Item Name: Crosstube Aft

DART AEROSPACE LTD		Work Order:	88807
Description: Crosstube High Aft (205/212)		Part Number:	D212-664-201
Inspection Dwg: D212-664-241	Rev: D	Page 1 of 1

DRAWING NO. D212-664-241	TITLE CROSSTUBE ASSY (205/212 HI AFT)	REV. D	DART AEROSPACE LTD ENGINEERING ORDER		D.E.O. NO. D212-664-241-D-1	SHEET NO. SHEET 1 OF 2	SCALE NTS
DRAWN	CHECKED	MFG. APPR.	APPROVED	DE APPR.			
DATE 11.04.07	DATE 11.04.11	DATE 11.04.12	DATE 11/04/12	DATE 11.04.12

DRAWING NO. D212-664-241	TITLE CROSSTUBE ASS'Y (205/212 HI AFT)	REV. D	DART AEROSPACE LTD ENGINEERING ORDER		D.E.O. NO. D212-664-241-D-2	SHEET NO. SHEET 1 OF 1	SCALE NTS
DRAWN <i>Q</i>	CHECKED <i>ASS</i>	MFG. APPR. <i>Q</i>	APPROVED <i>MP</i>		DE APPR. <i>MP</i>		
DATE 11.07.15	DATE 11.07.20	DATE 11.07.21	DATE 11/07/21		DATE 11.07.21

FIGURE 1: SUPPORT INSTALLATION

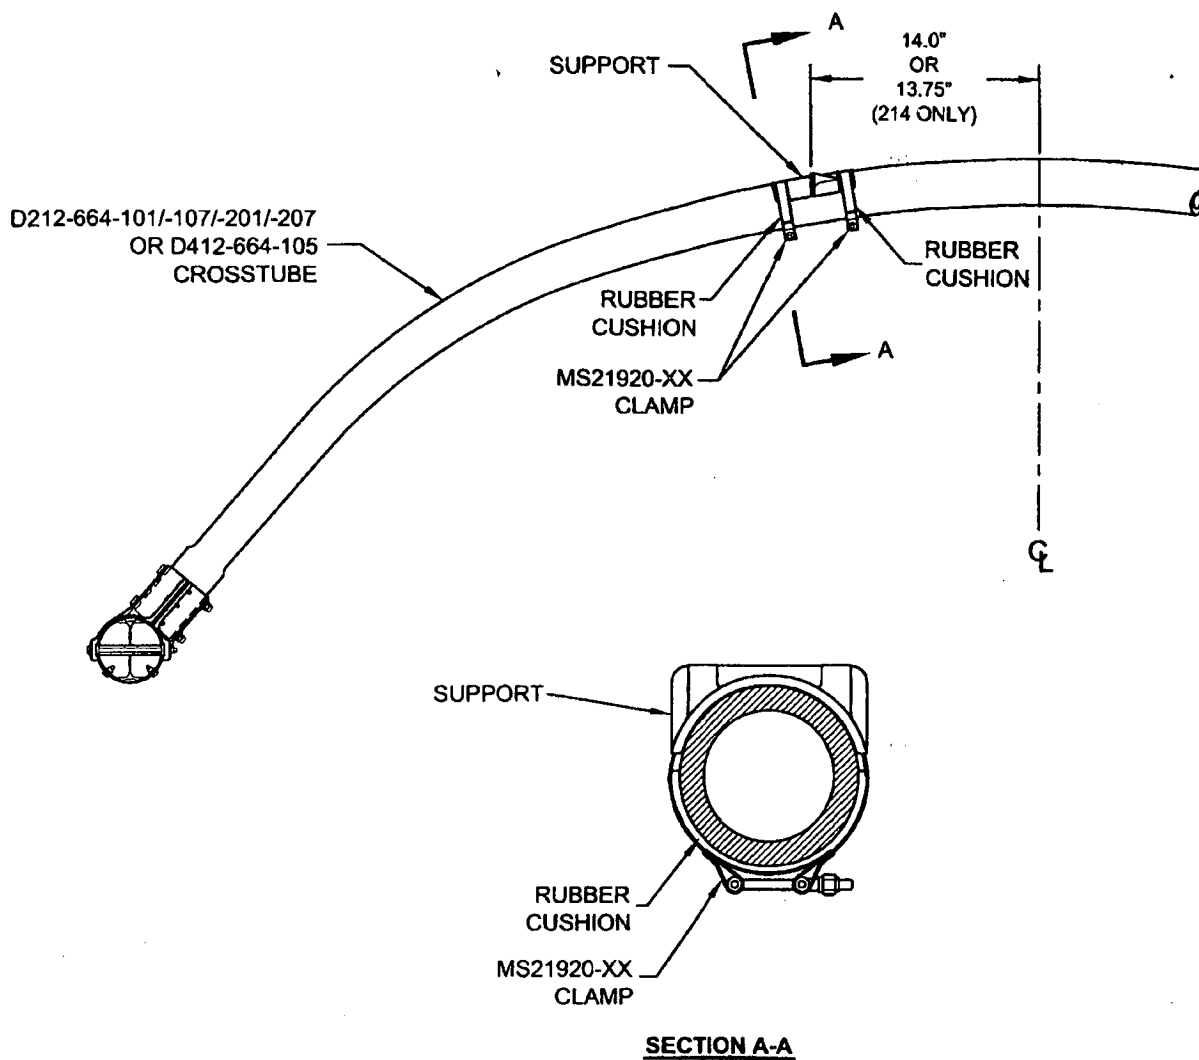
The supports on the following crosstubes are now installed using Proseal instead of Magnobond:

For the crosstubes listed above, section 32.4 of ICA-D212-664 is amended as follows. Use Figure 1 of this service instruction and Figures 32-2 to 32-9 of ICA-D212-664 for further reference. For crosstubes of an earlier change number, it is recommended that if the supports are removed, the supports should be reinstalled using the procedure listed below.

- 32.4.5 Apply a 0.04" to 0.07" thick layer of Proseal 890 Class B or AMS-S-8802 Class B sealant underneath applicable support and install support as shown in Figure 1 of this service instruction.

- 32.4.6 Install the clamps opposite to crosstube support as shown in section A-A of Figure 1. Install rubber cushions underneath each clamp around the bottom circumference of the crosstube up to the crosstube centerline. Torque clamps 80-100 in-lb (9.0-11.3 Nm). It is acceptable to use smaller or larger sized MS21920-XX clamps than those listed in ICA-D212-664, ensure that after torquing the clamps per this instruction, the nuts are in safety but not bottomed out

**D212-664-241/-241B
ASSEMBLY DETAIL**

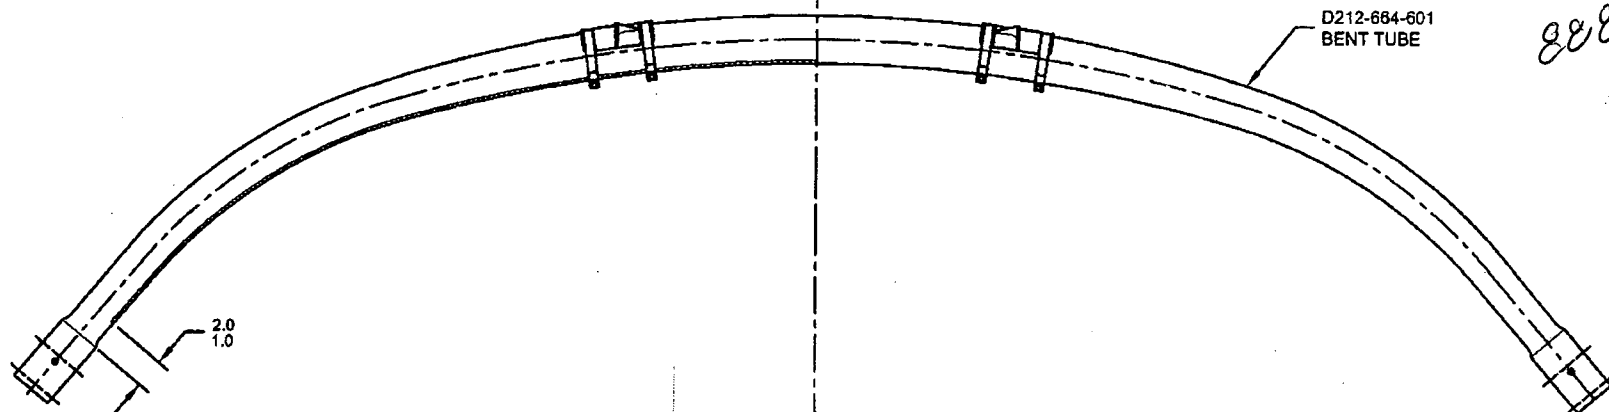
ADD AN INSPECTION WINDOW TO UNDERSIDE OF CROSSTUBE.

NOTES 2 OF SHEET 1 IS AMENDED AS FOLLOWS:

- 2) FINISH: CHEMICAL CONVERSION COAT PER DART QSI 005 4.1
PRIME INSIDE AND OUTSIDE PER DART QSI 005 4.2
MASK UNDERSIDE OF CROSSTUBE AS SHOWN (HATCHED AREA) AND
PAINT OUTSIDE PER DART QSI 005 4.2
REMOVE MASKING AND APPLY CLEAR COAT

MASK AREA PRIOR TO PAINTING,
REMOVE MASKING AFTER PAINT
AND APPLY CLEAR COAT

CRUSHING OF D212-664-201

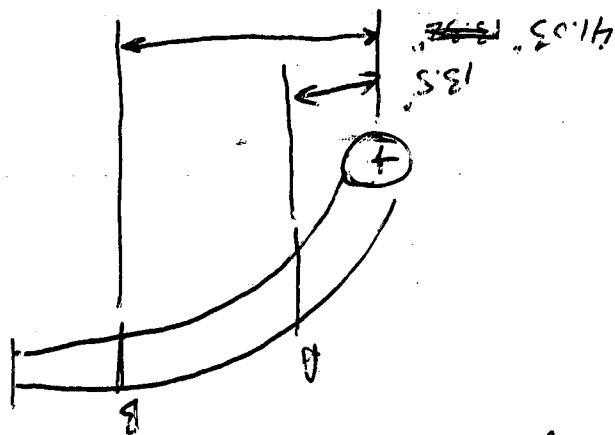
Acceptability of 8% CRUSHING

Point A: $OD1 = 2.548$, $OD2 = 2.492$, $I = 1.476$
 Crushing $(2.492 - 2.548) / (2.492 + 2.548) = 8\%$
 Point B: $OD = 3.25$, $ID = 2.22$, $I = 4.284$
